DEPARTMENT OF COMMUNITY DEVELOPMENT SERVICES

SUBJECT: **An Ordinance Approving a Preliminary Development Plan for a Planned Unit Development** (602 South Lincoln Avenue / CCH Development, LLC & CMH Development, LLC – Plan Case 2411-PUD-20)

An Ordinance Approving a Final Development Plan for a Planned Unit Development (602 South Lincoln Avenue / CCH Development, LLC & CMH Development, LLC – Plan Case 2412-PUD-20)

Supplemental Memorandum

C
A0.1
PERVIOUS PAVER SYSTEM DETAIL
NO SCALE

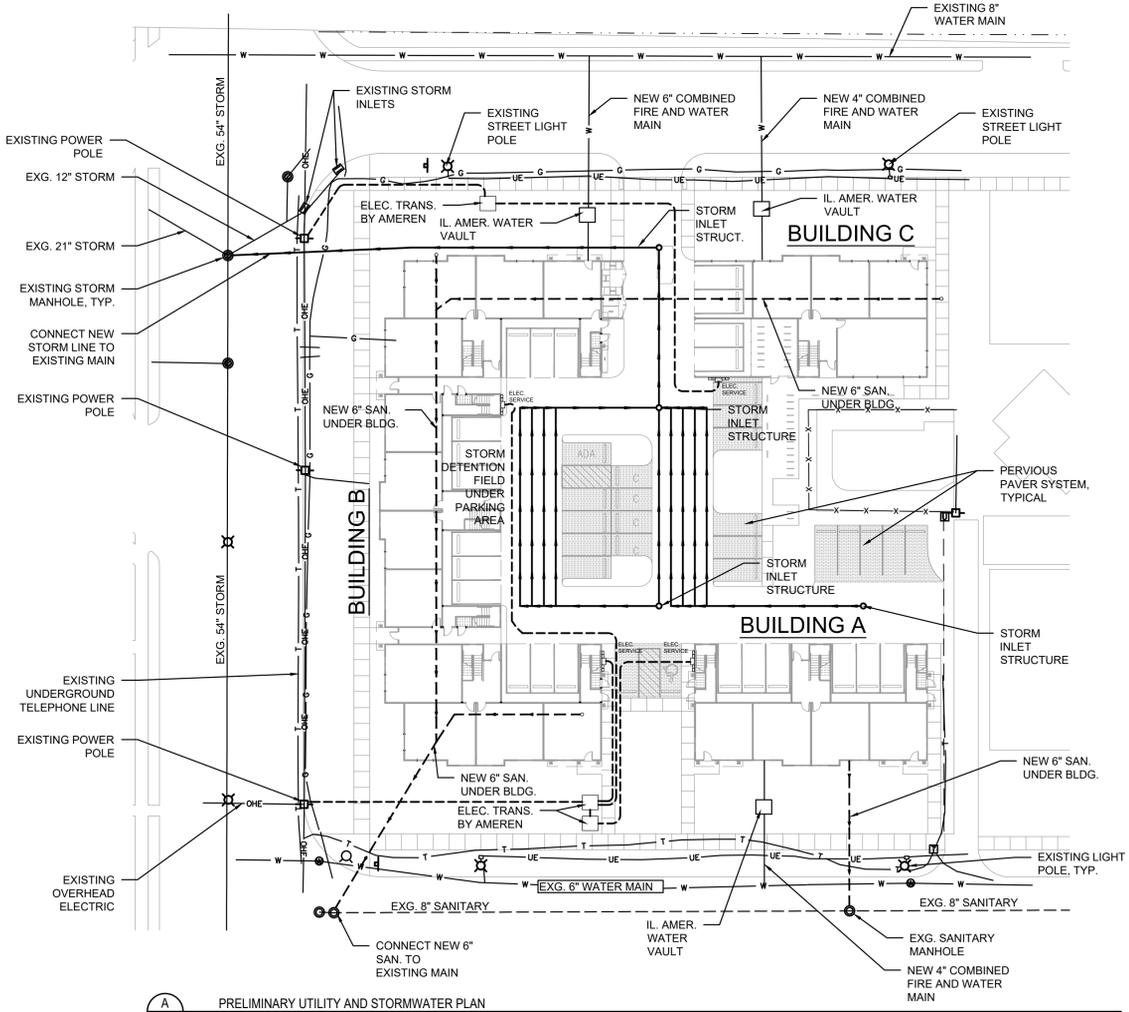
Condition 5: That the proposed permeable pavement become permeable pavers, and may be extended to other areas of the parking lot, to increase stormwater management and tree preservation.

This condition requires a specific type of permeable pavement in areas identified for permeable pavement, and allows for other areas of the parking lot to be paved with permeable pavers as well.
